PERMIT DRAWINGS

Project name:
Schussboomer Hangar

LIFE SAFETY & EMERGENCY EGRESS PLANS

2 Fire Extinguisher Detail

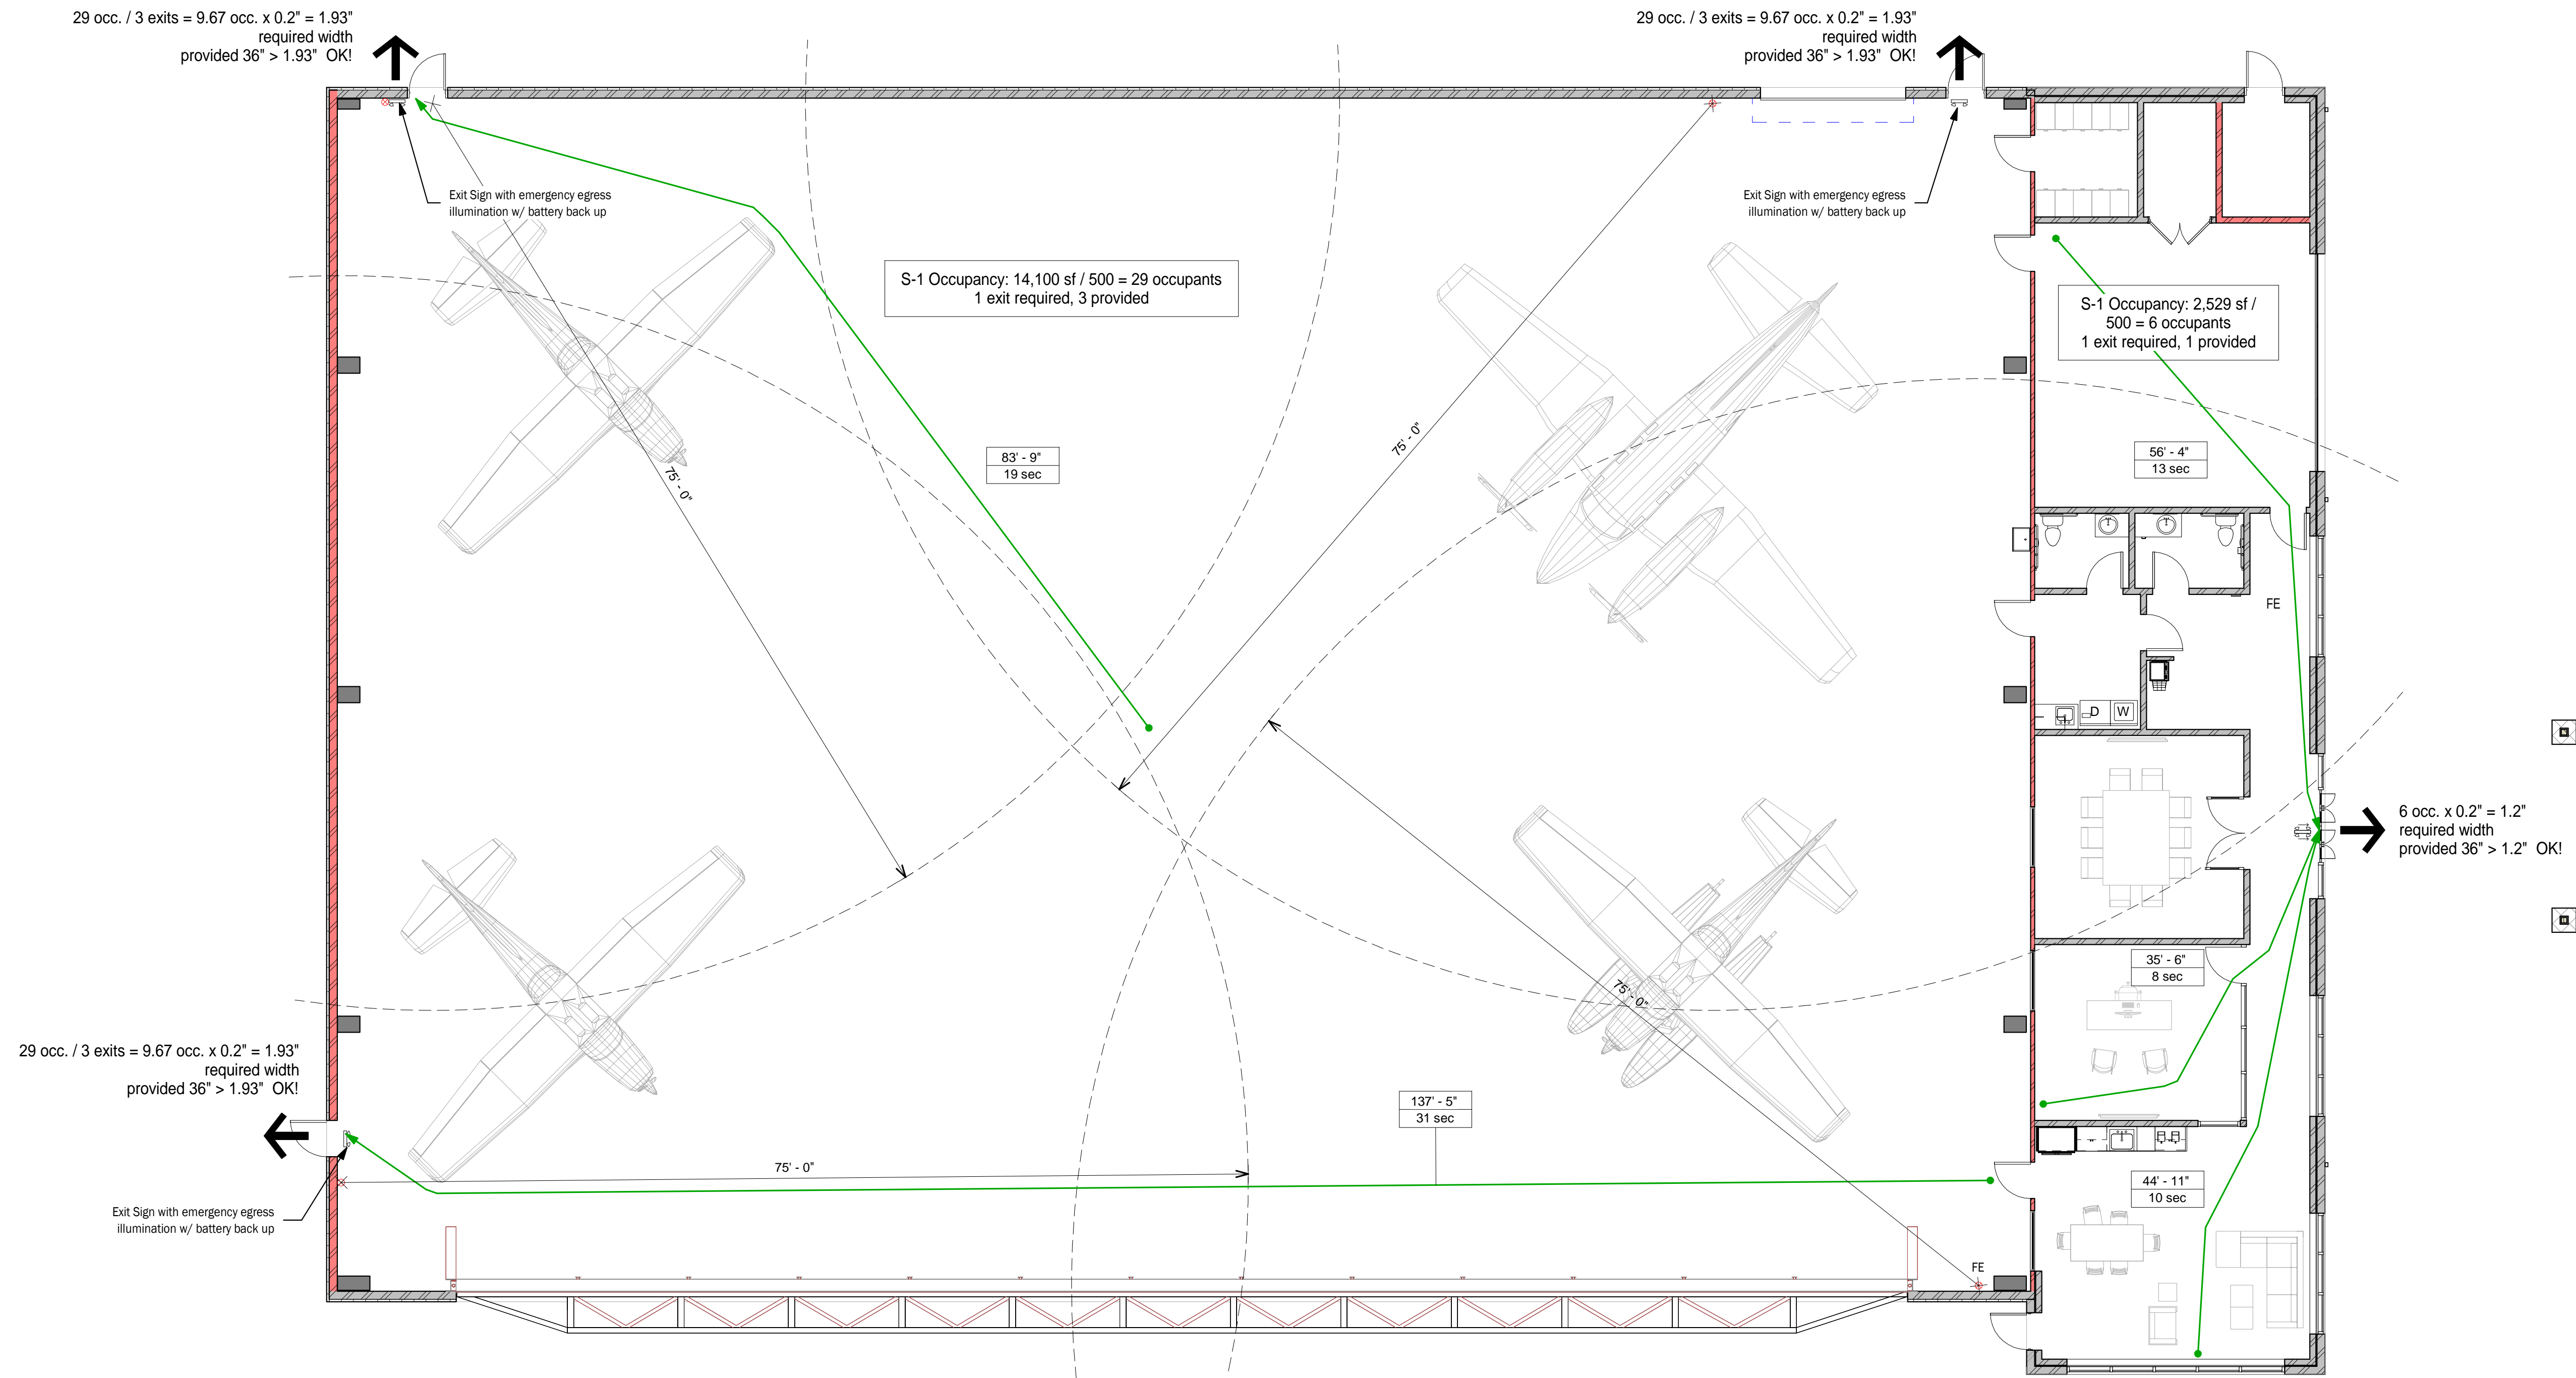
Fire extinguisher cabinet - may protrude ONLY 4" maximum into space

The dashed box indicates the required location that a fire extinguisher is to be located.

The Fire Extinguisher must be more than 6" above finish floor, but no more than 60" above finish floor with a clear floor space of 30"
